36 FLASK WALK NW3 1HE

A geotechnical and structural assessment of a basement planning application 2015/3753/P and its potential impact on 34 and 38 Flask Walk

Report reference G1511-RP-01-E1

Figure 1

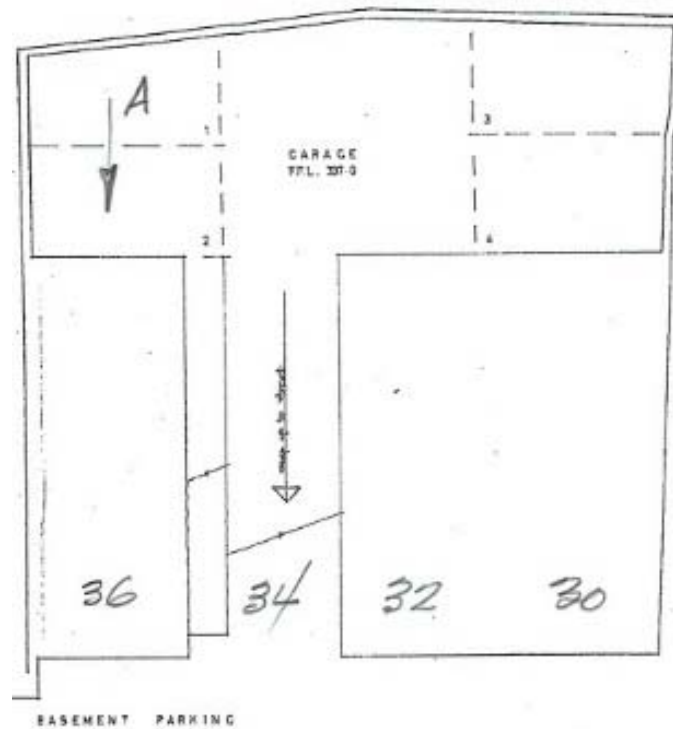
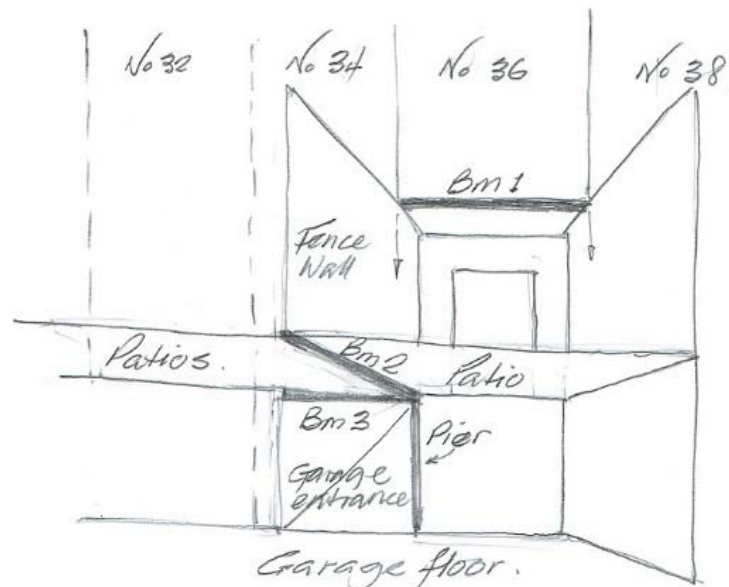
69. In addition to the party wall stability issues already discussed, it is necessary to demonstrate that the heavily loaded concrete pier at the rear end of the 34/36 party wall will be adequately supported during the basement excavation process. The pier

supports the rear walls of both Nos 34 and 36, the party fence wall between the two properties and some part of both patios (see figure 1).

70. The situation has not been recognised in the application which thus fails to demonstrate adequate support and stability of this element of the structure.

Beam 1 supports the rear wall of No.36 above first floor supports
Beam 2 supports the 34/36 party and fence walls, Beam 1 and part of the patios
Beam 3 supports the rear wall of No 34 and part of the patio
The Pier or end of the 34/36 party wall supports Beams 2 & 3 and would need to be supported by the proposed basement.
